FDI	ENGINEERING CHANGE ORDER		ECO NO: 10-070
			Page 1 of 1
TITLE	DWG NO.	CURRENT REV	NEW REV
DK CARRIER	CARRIER	3	3.1

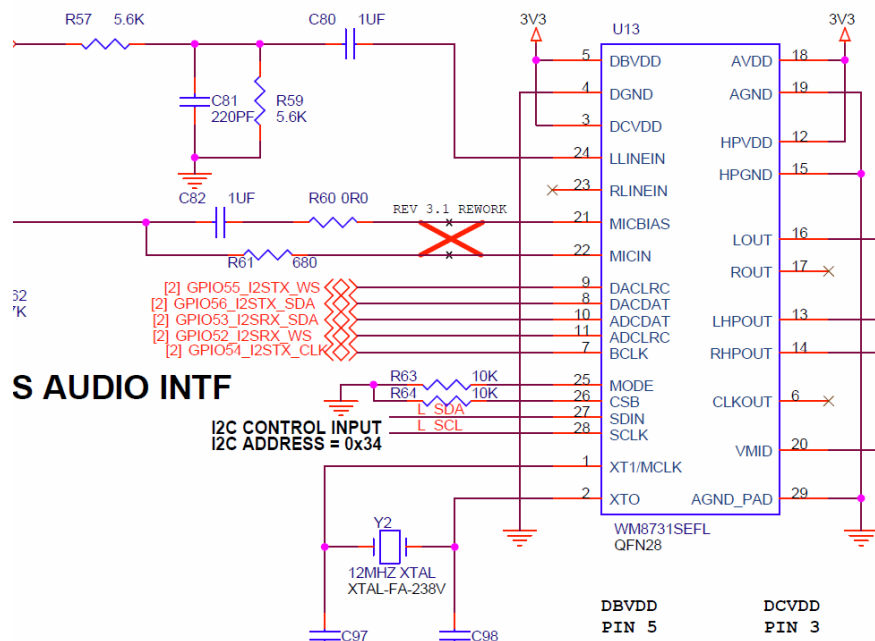
The microphone input signals are swapped on the Audio Codec

1. On U13, swap signals going to pins 21 & 22 as shown below;
